ADDENDUM NO. 05
January 8th, 2025

PKG 3B – GPHS ATHLETICS, ACADEMIC & MULTI-PURPOSE FACILITY

Prepared by: PBK
11 Greenway Plaza, 22nd Floor
Houston, TX 77046-1104
PBK Project No: 240539

FOUNDATION PLAN - AREA A
S-101A
FOR BLUEBEAM LABELINGDOOR:

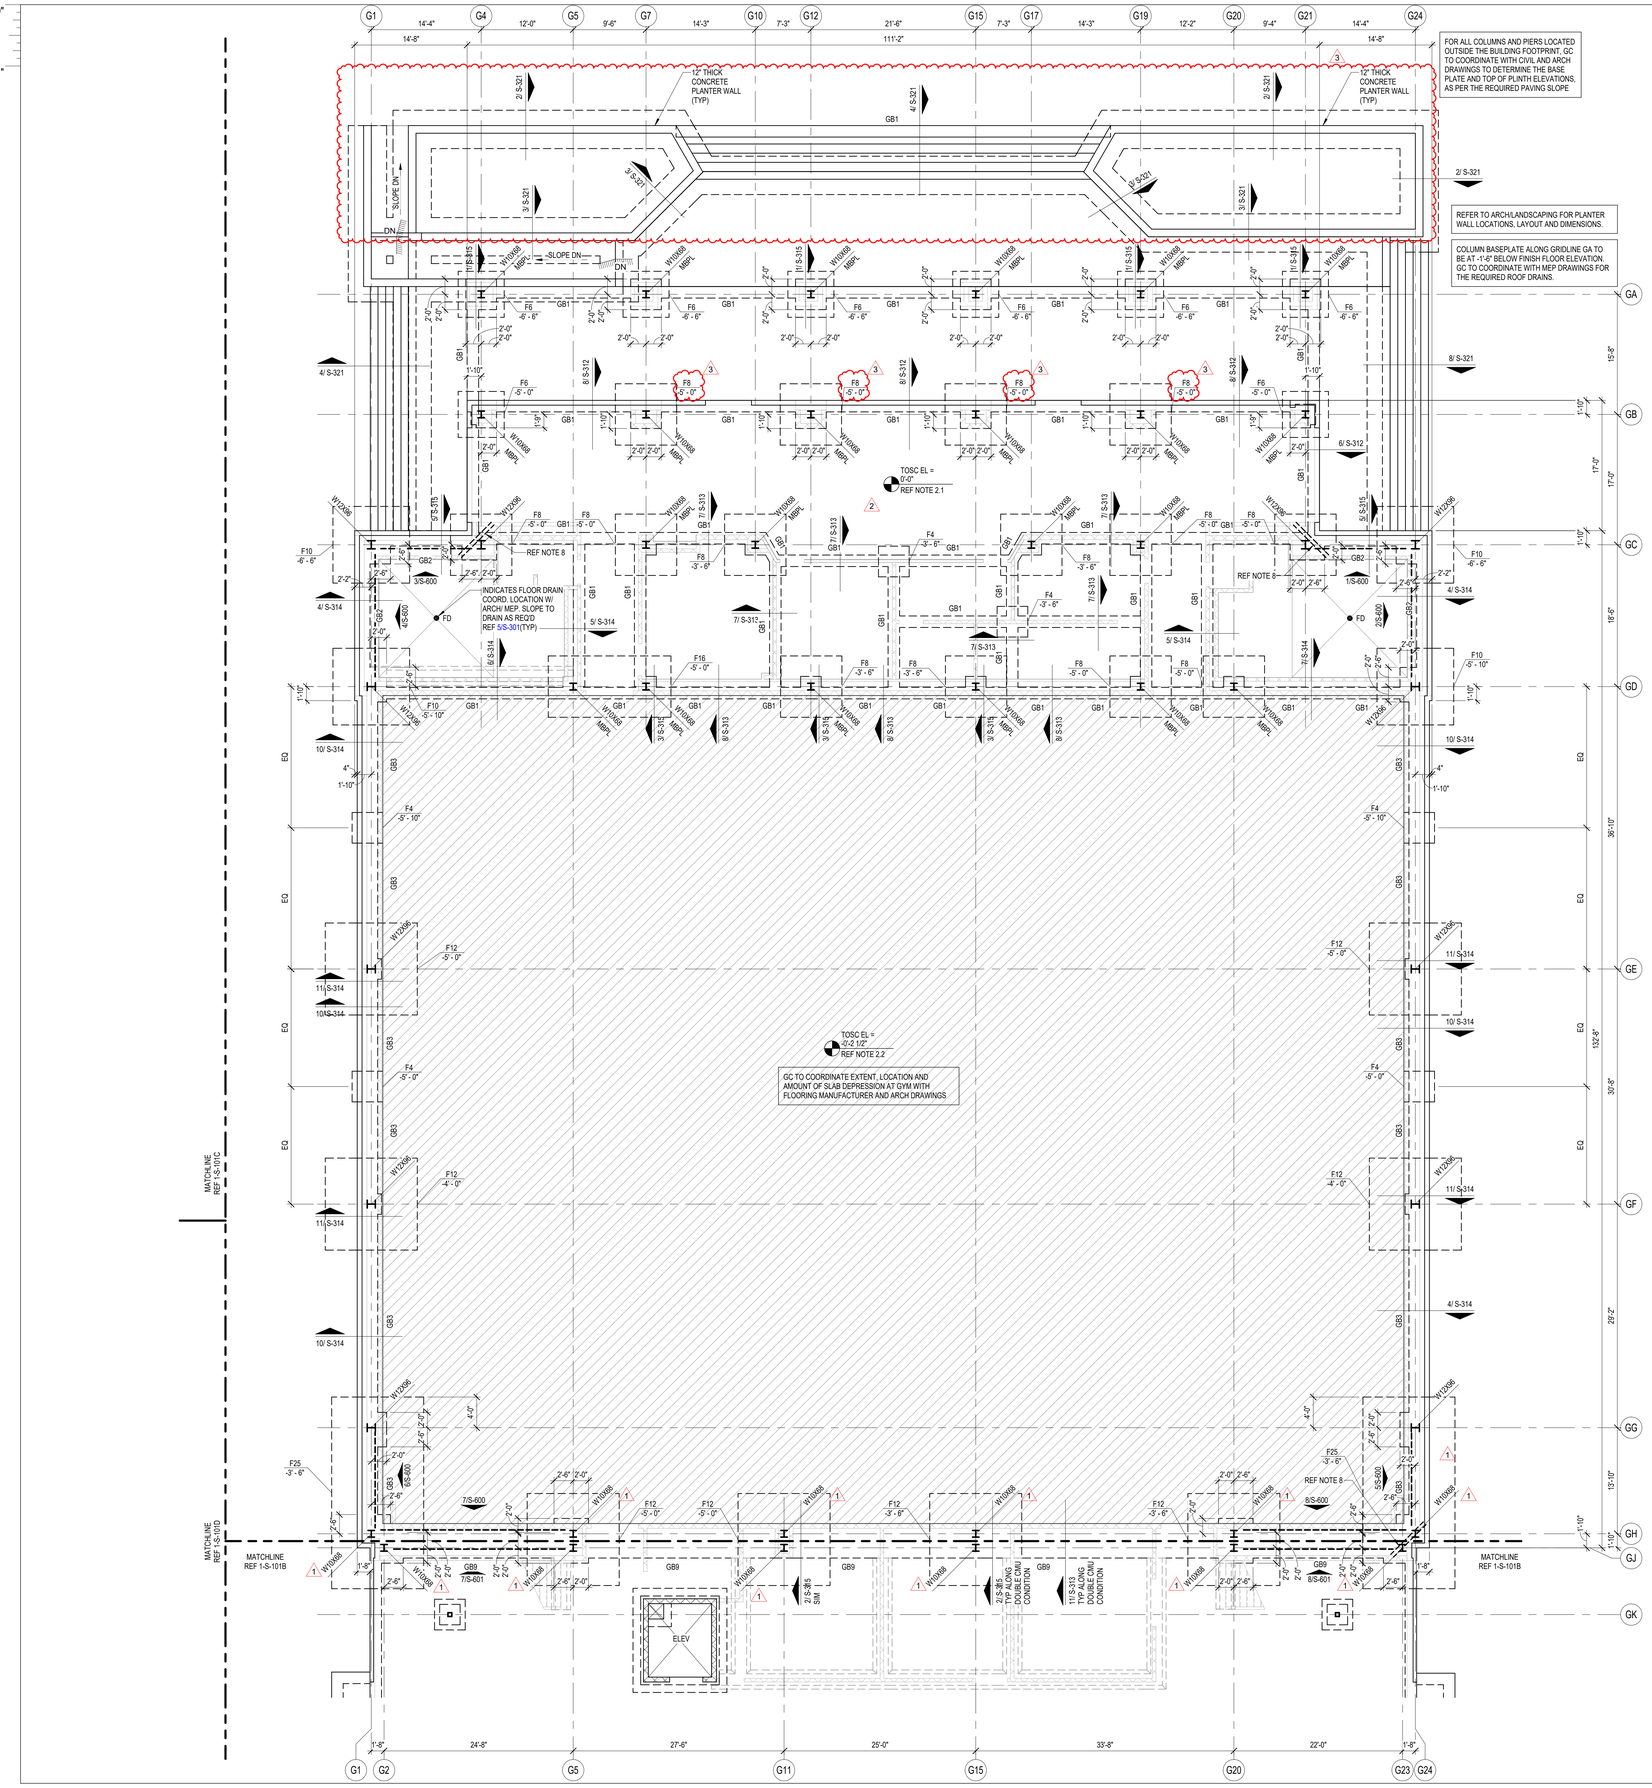
Question 03: With regards to the floor finish in the Multi-Purpose Room, if it is to be Synthetic Turf with a foam pad please confirm if there will be a concrete slab underneath it. S-101G looks to indicate this as it calls for a depressed slab but it is not totally clear.

i. Response: The floor finish of the multipurpose room will be installed in a separate phase. Exposed concrete slab only, refer to architectural & structural drawings for depression dimension.

01 LEVEL 1 - AREA F NEW MULTIPURPOSE FACILITY FLOOR PLAN
1/8" = 1'-0"

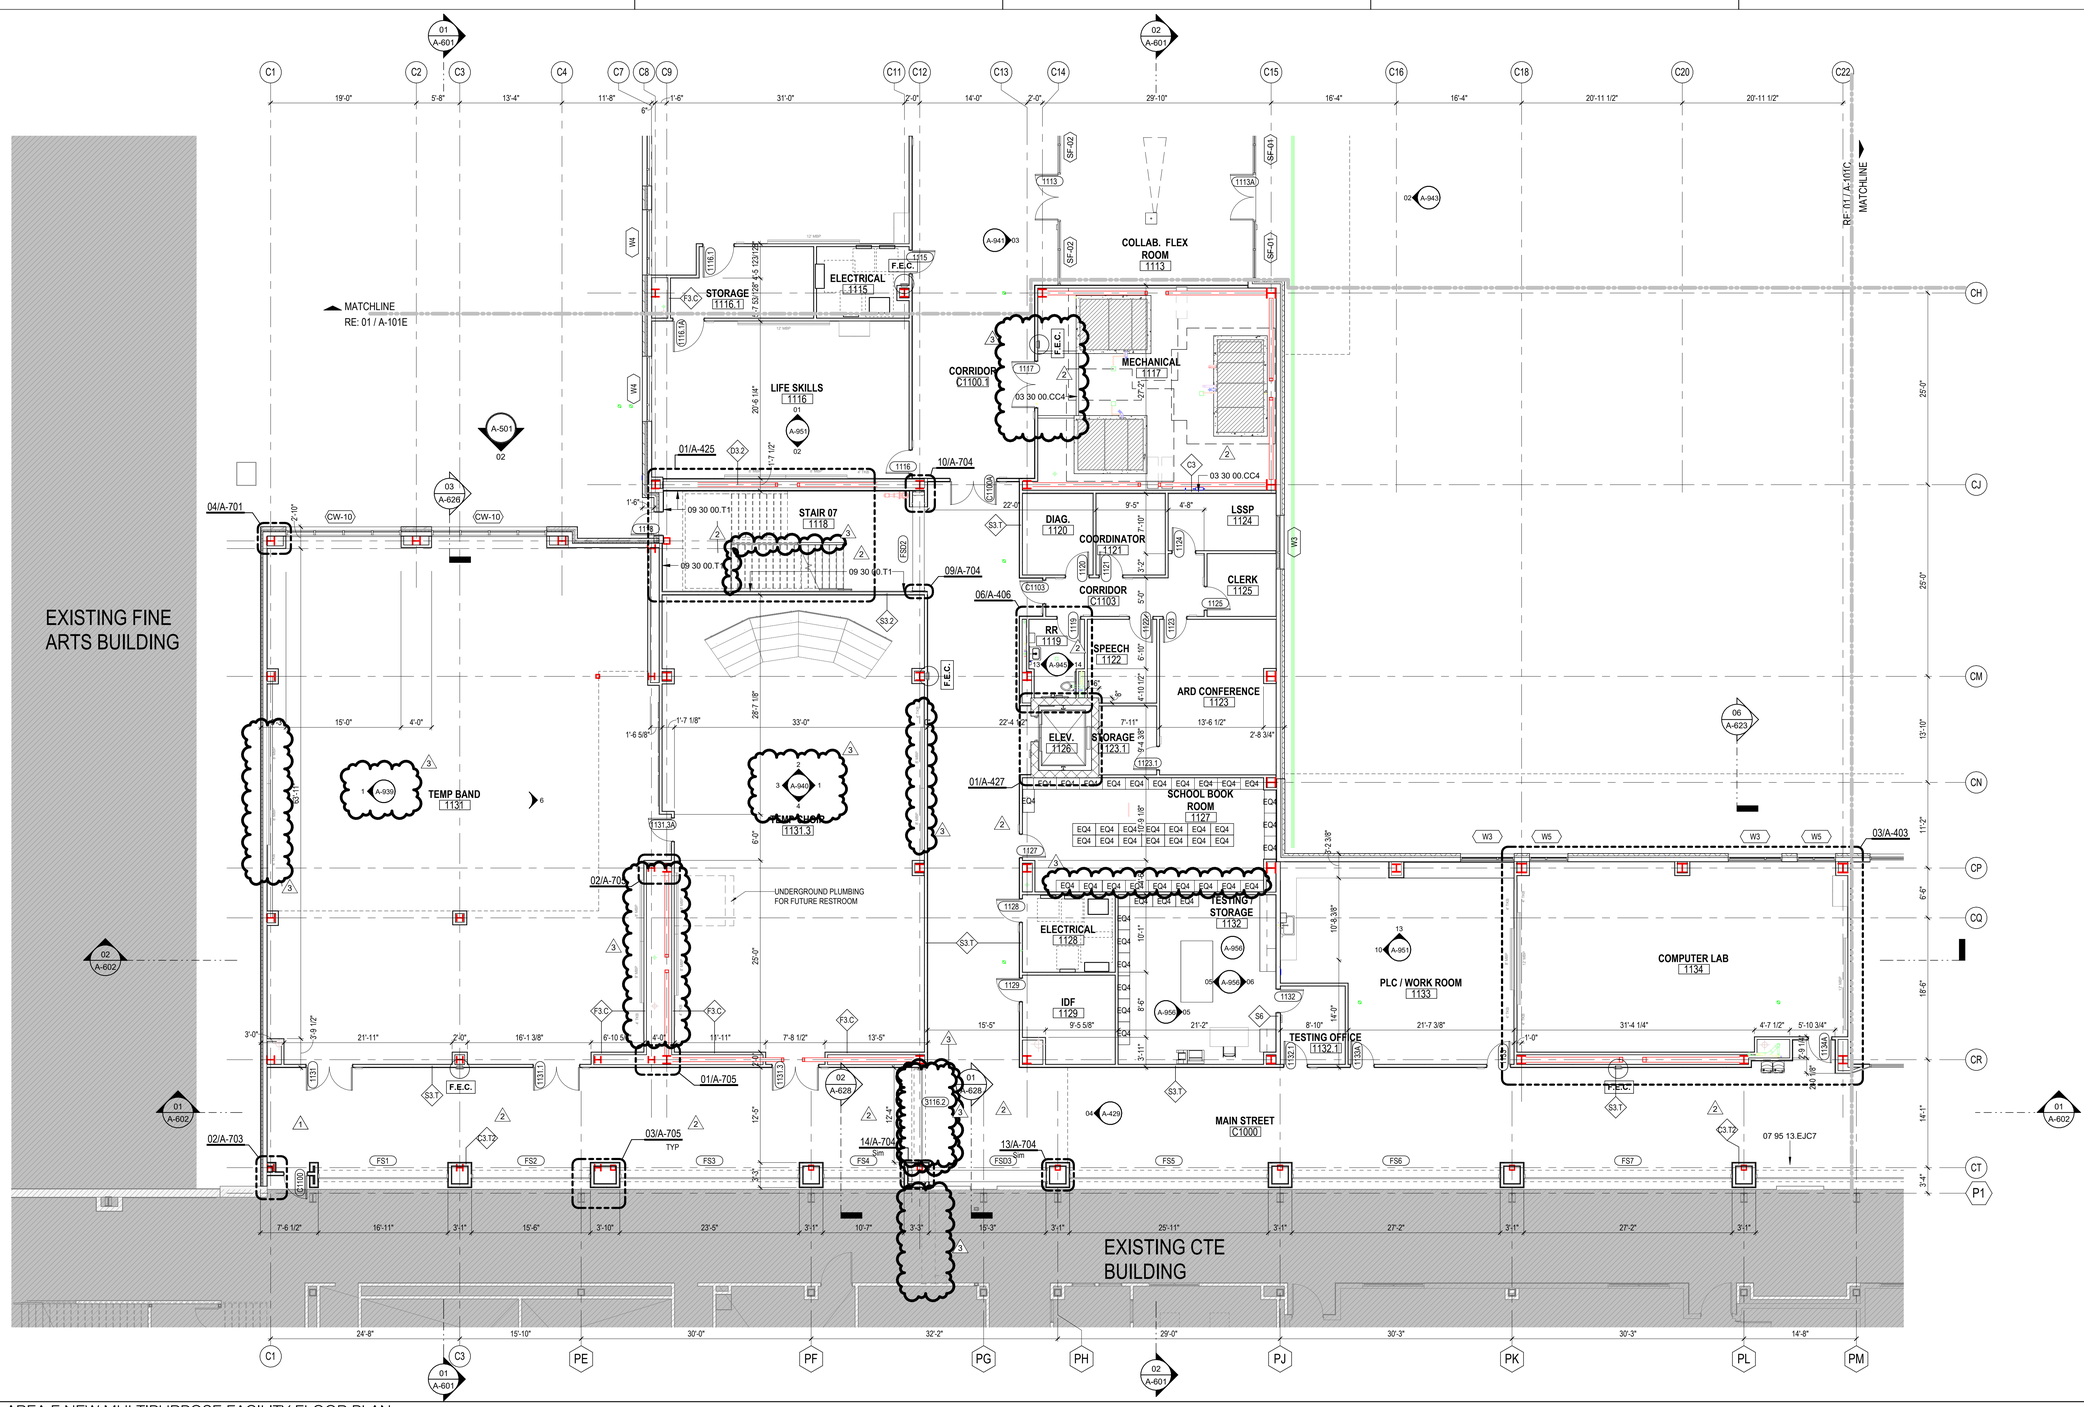
Question 36: Please clarify if all the walls in the multi-purpose room are per the elevations shown on A942 & A943. We ask this because per these elevations, most of the walls are CMU with brick veneer being only applied on the east wall. Elevation 2 shows all CMU but there is a section callout on A-102D that refers us to detail 6/A623 which shows brick veneer.

i. Response: Detail has been updated to show the correct material detail 04/A-726. Refer to ADD 05.
